2023–15–05 The Boeing Company:

Amendment 39–22517; Docket No. FAA–2023–1650; Project Identifier AD–2023–00795–T.

(g) Airplane Flight Manual (AFM) Revision

Figure 1 to paragraph (g) - Engine anti-ice AFM revision

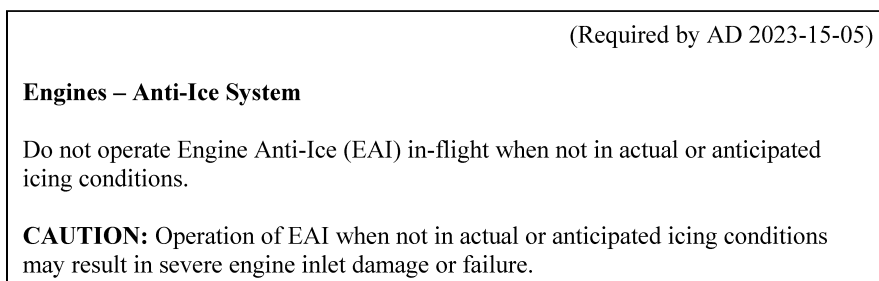
This AD was prompted by a report indicating that use of engine anti-ice (EAI) in dry air for more than five minutes during certain environmental and operational conditions can cause overheating of the engine inlet inner barrel beyond the material design limit, resulting in failure of the engine inlet inner barrel and severe engine inlet cowl damage. The FAA is issuing this AD to address use of EAI in certain environmental

and operational conditions. The unsafe condition, if not addressed, could result in departure of the inlet and potential fan cowl failure and departure from the airplane. The departure of the inlet may cause fuselage and/or window damage, potentially resulting in decompression and hazard to window-seated passengers aft of the wing and/or impact damage to the wing, flight control surfaces, and/or empennage, which could result in loss of control of the airplane. Inlet loss also causes significantly increased aerodynamic drag and asymmetric lift due to wing blanking, which risks fuel exhaustion on certain flights, resulting in a forced off-airport landing and injury to passengers.

Within 15 days after the effective date of this AD: Revise the Limitations Section of the existing AFM to include the information specified in figure 1 to paragraph (g) of this AD. This may be done by inserting a copy of figure 1 to paragraph (g) of this AD into the existing AFM.
